PRODUCT/PROCESS CHANGE NOTICE (PCN)

ATTACHMENT 1 - PCN # : TB1601-01

PCN Type: Manufacturing Site - Alternate Test & Backend Location

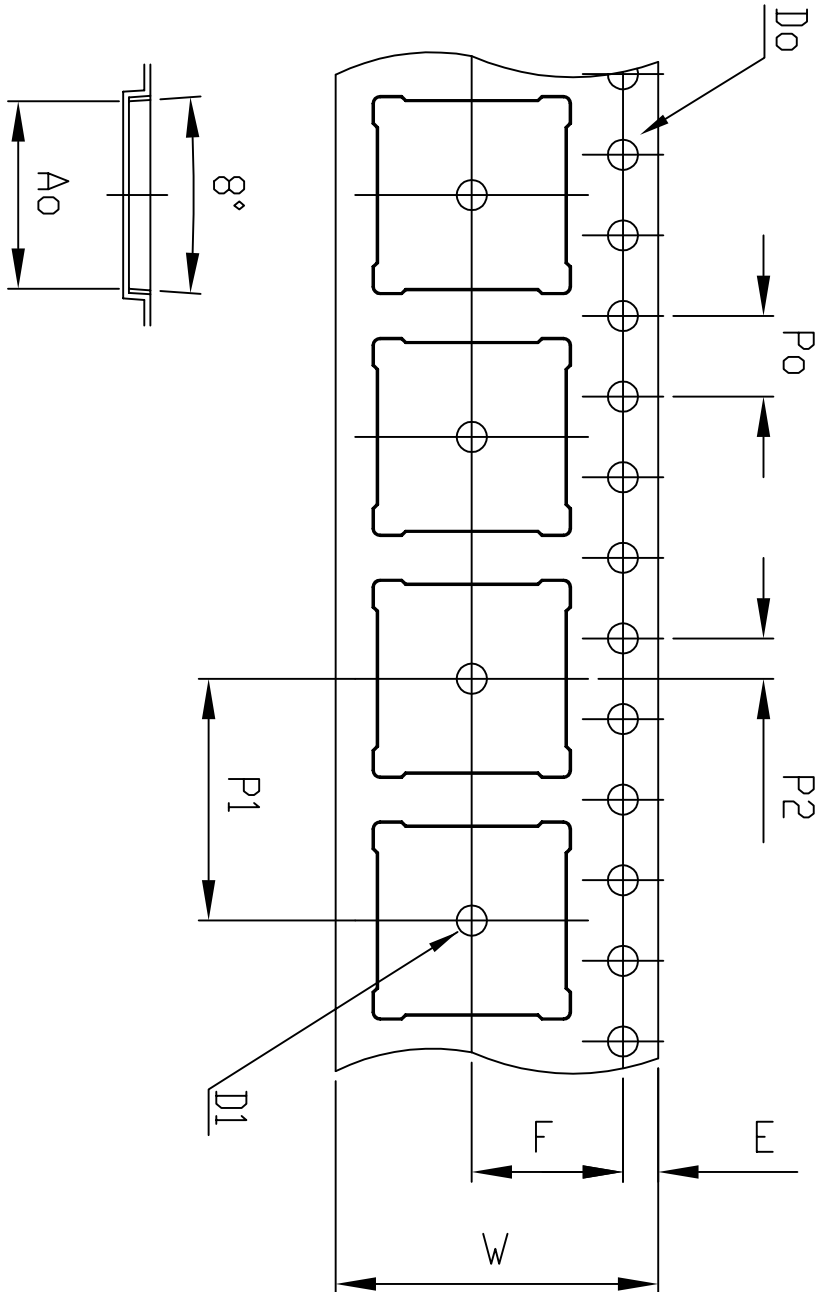
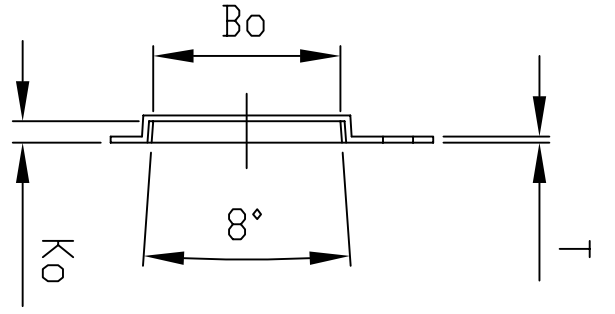
Carrier Tape and Plastic Reel comparisons:

Table 1: Carrier Tape Comparisons

Item	Vendor	Carrier Dimensions		Cavity Dimensions (mm) ±0.1 or Specific				Top View	Drawing
		W (mm.) ±0.3	P1 (mm.) ±0.1	A0	B0	K0	K1		
IDT	PCT QFN9x9GP-20B3-360C-SD	16	12	9.3	9.3	1.05	NA		Refer Attachment 3
Sigurd	ADVANTEK ML0909-D	16	12	9.3	9.3	1.05	NA		Refer Attachment 4

Attachment 5 - Plastic Reel

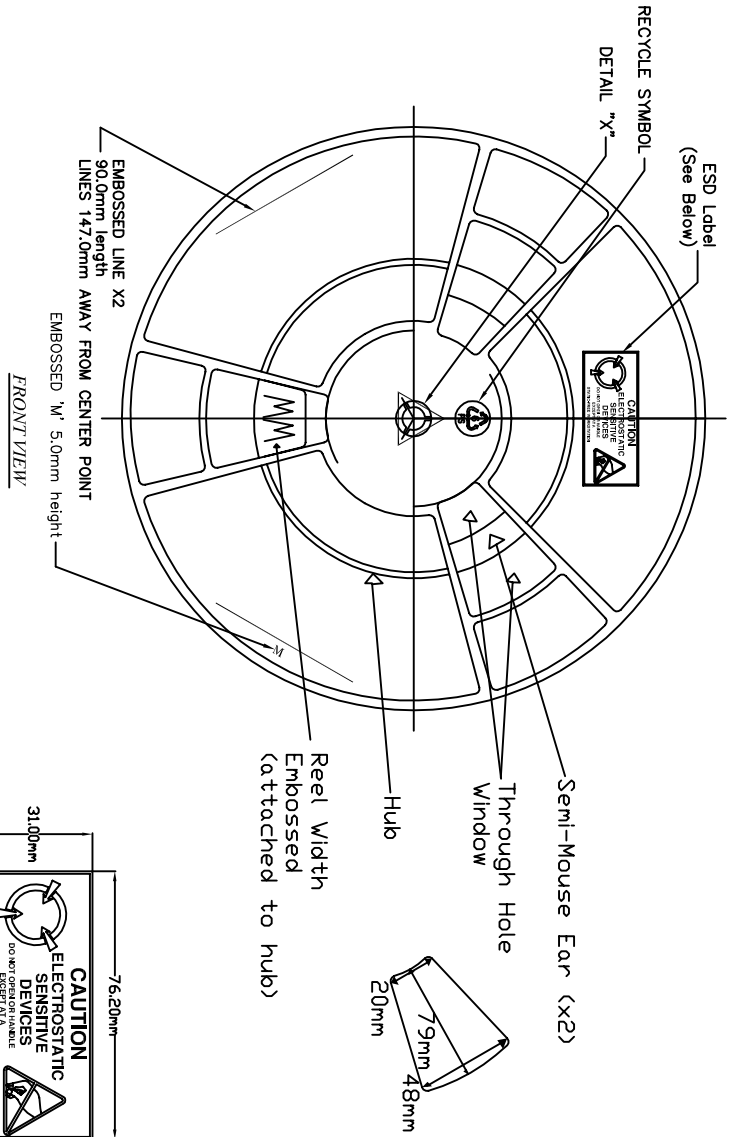
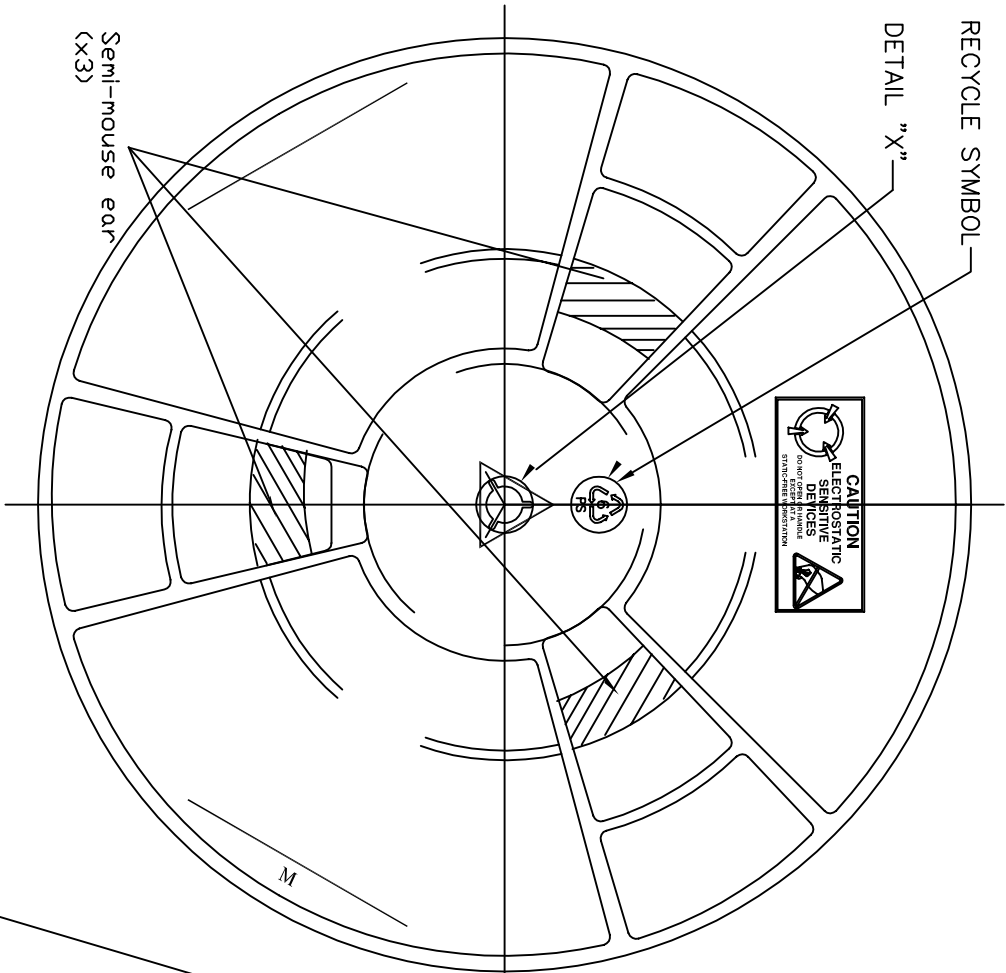
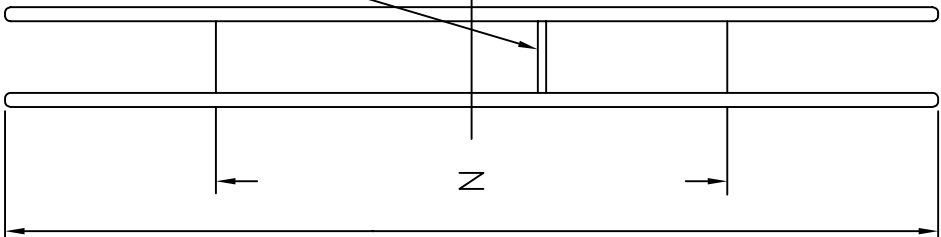
Table 2: Plastic Reel Comparisons

Item	Vendor	(A) Reel Dia. (inch)	(N) Hub Dia. (inch)	Color	Snapshot	Drawing
IDT	TAIPEX 3.3C161307(BLK)	13"	7"	Black		Refer Attachment 5
Sigurd	TAIPEX 3.3C161307(BLK)	13"	7"	Black
